**Camshaft Cover Oil Leaks – AJ16 Engine –
Revised Bolt Torque Specification**

MODEL 1995-96 MY
Sedan (4.0)Range
VIN
720001-767554

ILLUSTRATION 1

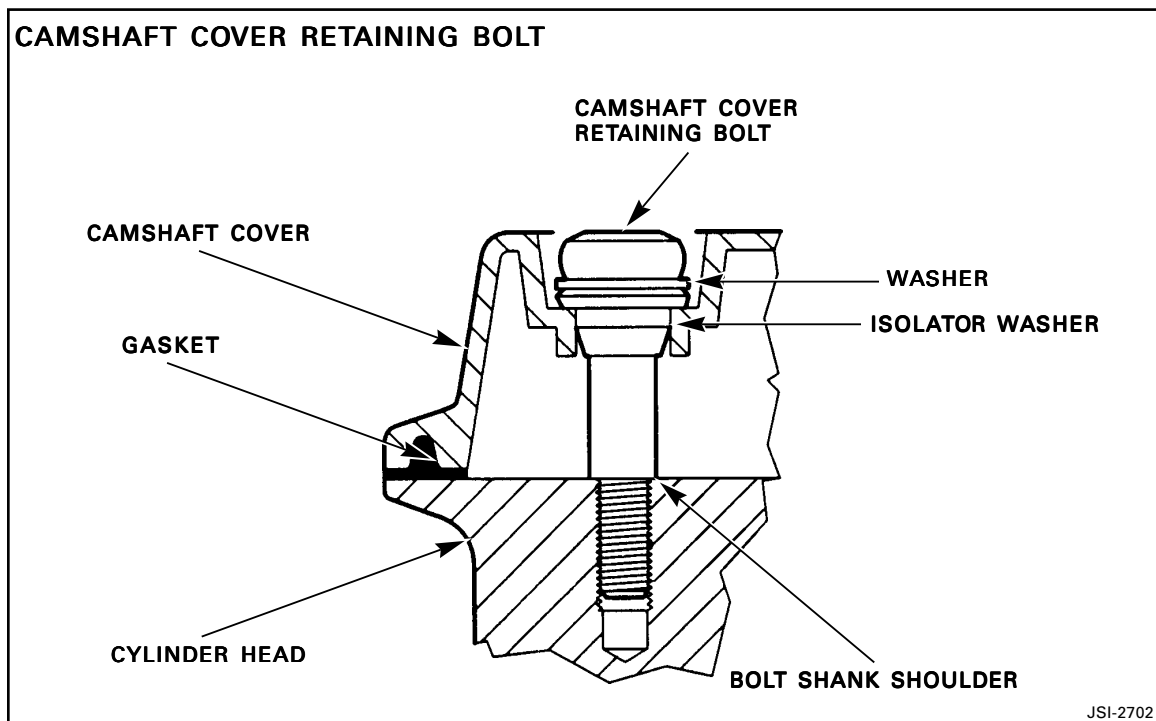
The torque specification for the camshaft cover retaining bolts has been revised beginning with VIN 767555. The revised torque specification ensures that the shoulder on the shank of the bolt bottoms against the surface of the cylinder head (Illustration 1) to achieve even compression of the camshaft cover gasket and to reduce the incidence of oil leakage.

ILLUSTRATION 2

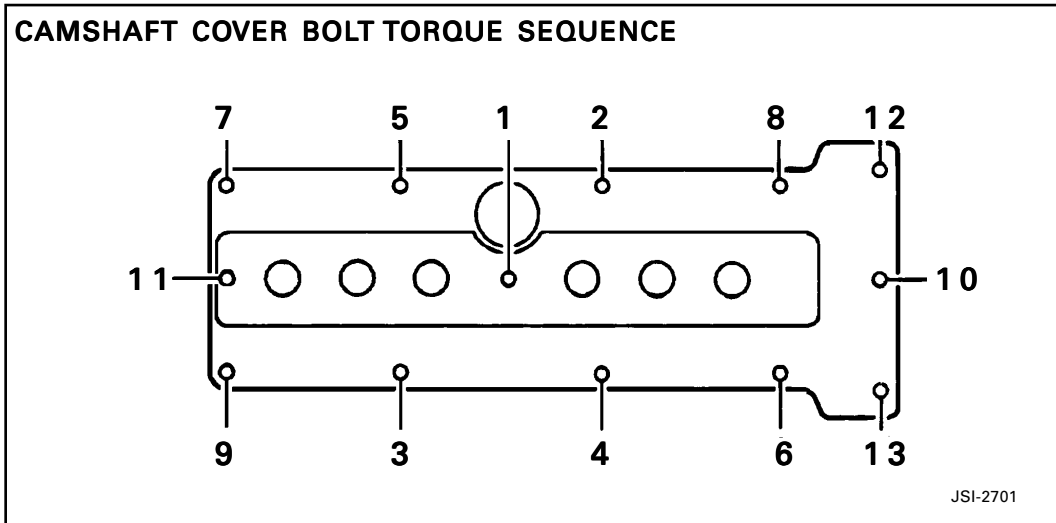
3. Install **new** seals in the spark plug wells.
4. Install a **new** camshaft cover gasket.
5. Install the camshaft cover and tighten the 13 retaining bolts "finger-tight."
6. Final tighten the retaining bolts in the sequence shown in Illustration 2
Torque the bolts to 5 lb. ft. (6.5 Nm).
7. Install new seals when reinstalling the "on-plug" ignition coils.
